ITEM 6.1: **Design Review Permit – 8020 Foothills Boulevard – NIPA PCL HP-1 – Innovation Park Building – File #PL20-0019**

The applicant requests approval of a Design Review Permit to allow the construction of 150,926-square-foot, one-story office building within the Roseville Innovation Park (formerly known as the Hewlett-Packard Campus), with associated parking, lighting, and landscaping.

Figure 3: Site Plan

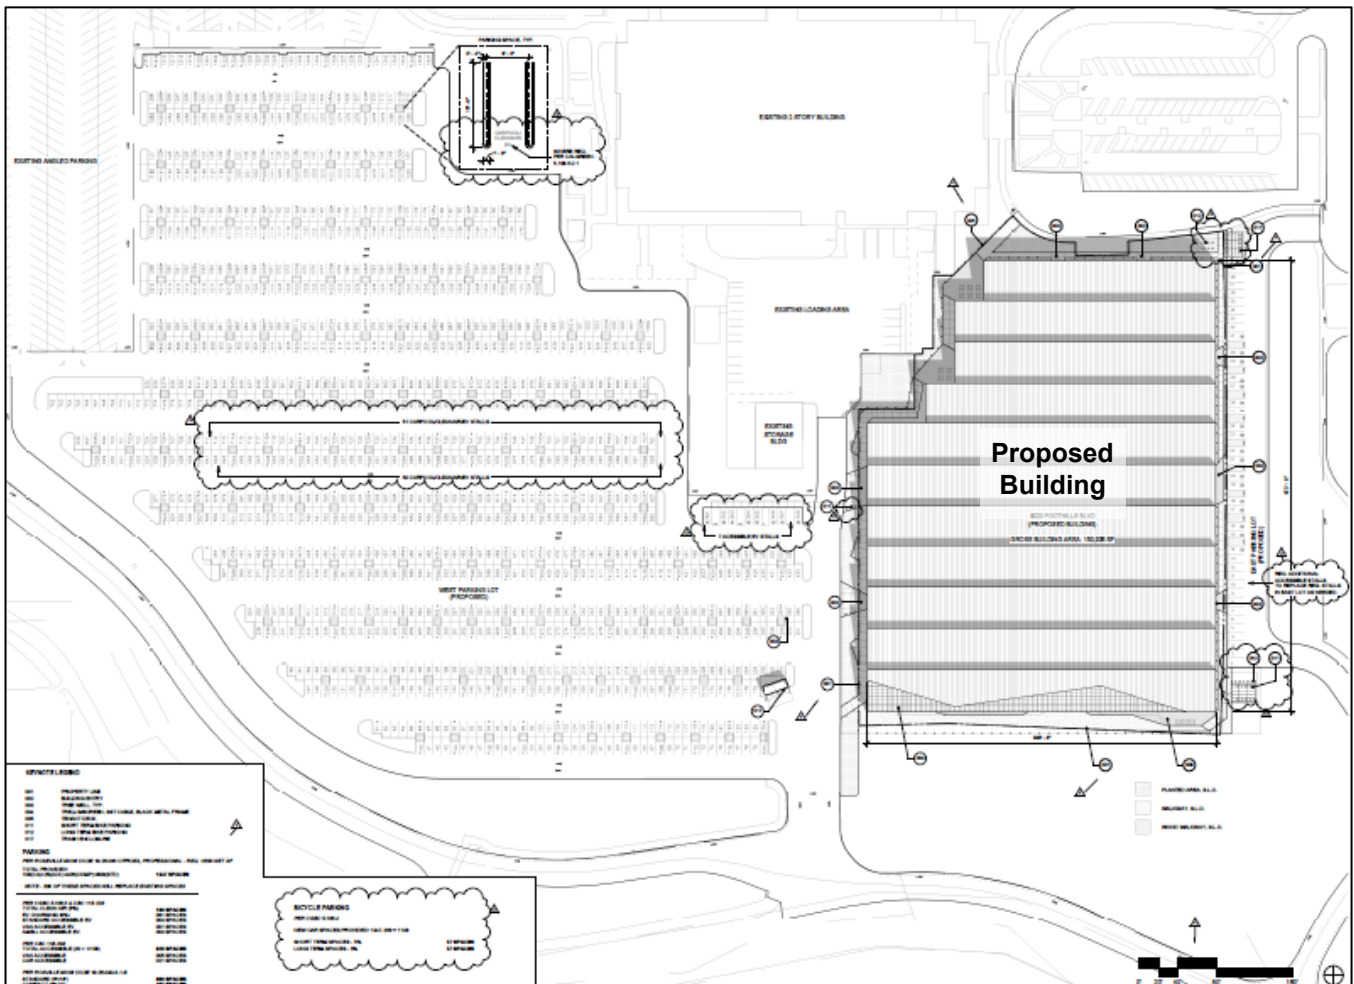
Vehicle Access and Circulation: Access to the project site will be provided by an existing driveway along the southern portion of the site, which connects to a roadway intersecting with Foothills Boulevard to the east. The project includes multiple internal drive aisles that provide access to the parking areas. The project was reviewed by the City Engineering and City Fire Department staff and was found to comply with refuse service standards and with emergency circulation requirements.

Parking: The Zoning Ordinance parking requirement for office uses is one (1) space per 250 square feet of net leasable square footage. The proposed total gross building area is 150,926 square feet. Since the net leasable square footage of the building has not yet been determined, an estimate of a 10% reduction of the total gross building area was used to determine the parking requirement. Based on this, the project requires 543 parking spaces. The project proposes a total of 1,347 parking spaces; 209 of these spaces will replace existing parking areas. A majority of these spaces will be located to the west of the building with the exception of 39 spaces, which will be located to the east. The project meets and exceeds the Zoning Ordinance parking requirements. In addition, the project will provide bike parking and spaces dedicated to carpool and electric vehicles consistent with the City's Alternative Transportation Department requirements.

Landscaping and Lighting: Landscaping for the project is provided in planters around the perimeter of the site, within the parking lot, at building entries and along the pedestrian walkways around the building. The City's minimum requirement of 50% shading in parking lots is accomplished with a mix of Japanese zelkova, autumn gold, and valley oak trees. The proposed planting plan is consistent with the Community Design Guidelines and with the City's Water Efficient Landscape Ordinance.

Figure 5: West Elevation

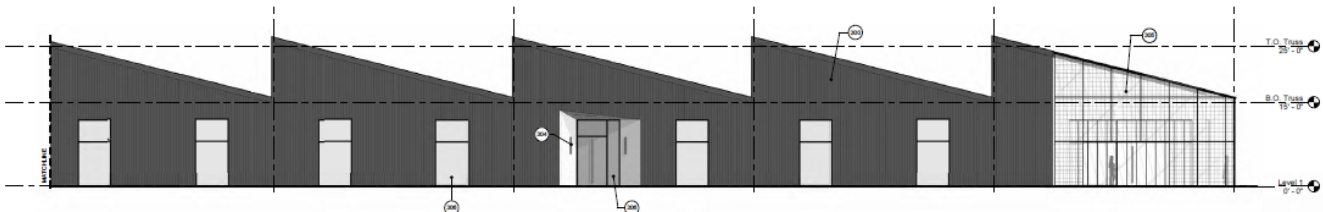
The applicant has identified that the project’s primary design objective is to provide as much natural light to the majority of the building floor area in order to create a sustainable building design. This is consistent with CDG Policy OI-43, which encourages green building design. To achieve this, the building is composed of a series of north-facing clerestory bays, which together create a “sawtooth” profile on the east and west elevations (see Figure 5). The sawtooth elements prevent heat from the sun and provide an ideal surface to mount solar panels on in the future. The building heights range from 15 feet to approximately 27 feet to the top of the sawtooth element, which is below the allowable 50-foot height limit established in the NRADG.

The building will be clad in dark gray corrugated metal siding and the entries will be recessed and emphasized with white stucco niches along the length of the façade. Fenestrations including glass windows with aluminum storefront framing are used to break up wall surface mass and height. The landscape at the building entries and along the pathways provides color and helps to soften the façade. Although the project introduces a new and modern design concept within the HP Campus Oaks project, staff finds the design is complementary and is of similar scale to the surrounding industrial development. Overall, staff finds that the project creates a visually engaging design consistent with the CDG and the NRADG.
